E5071A-05C

S E R V I C E N O T E

E5071A ENA Series Network Analyzer, 300 kHz to 8.5 GHz

When a measurement trace or output power shows troubles between 1.3 GHz and 2.1 GHz, or in full frequency range, replace A1 module with the latest one (E5071-6x571), and update E5071A Operating System at the same time.

Figure 1. Trace shows noise around 1.3 GHz to 2.1 GHz at preset setting.

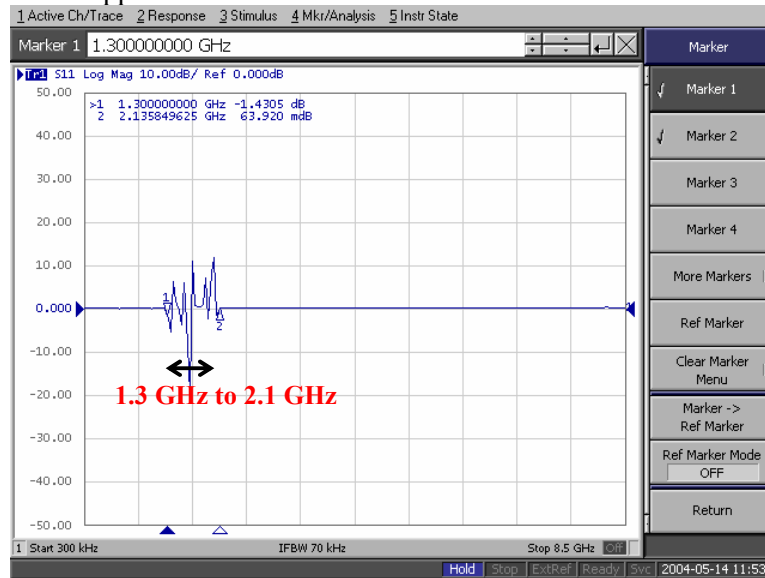
- The trace shows spike at 1.3 GHz or 2.1 GHz at the preset situation.
- The trace between 1.3 GHz to 2.1 GHz is more noisy than other frequency ranges.
- The power level of 1.3 GHz to 2.1 GHz is lower than other frequency ranges.
- Internal test of A1 ALC shows fail at SOP (f=1.3G) or LOP (f=1.3G) as Figure 2.

Above symptoms tend to appear after 30-minute heat run.
